City of Mississauga Department Comments

Date Finalized: 2022-03-30 File(s): A107.22

Application Details

Property Address: 792 Millworks Cres

Appendix 1 – Transportation and Works Comments

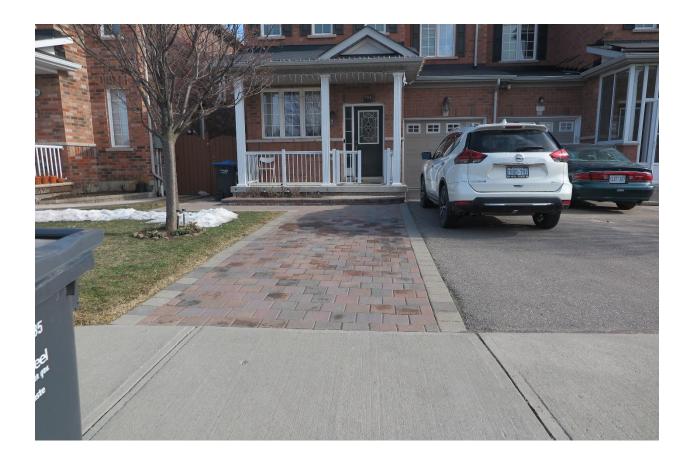
Enclosed for Committee's information are photos of the subject property. This department notes that with regard to the widened driveway within the municipal boulevard (the area between the municipal curb and property line) we would request that this area be reinstated with topsoil and sod should the application be modified to reflect a smaller driveway width within the subject property or if the application is not supported by the Committee.
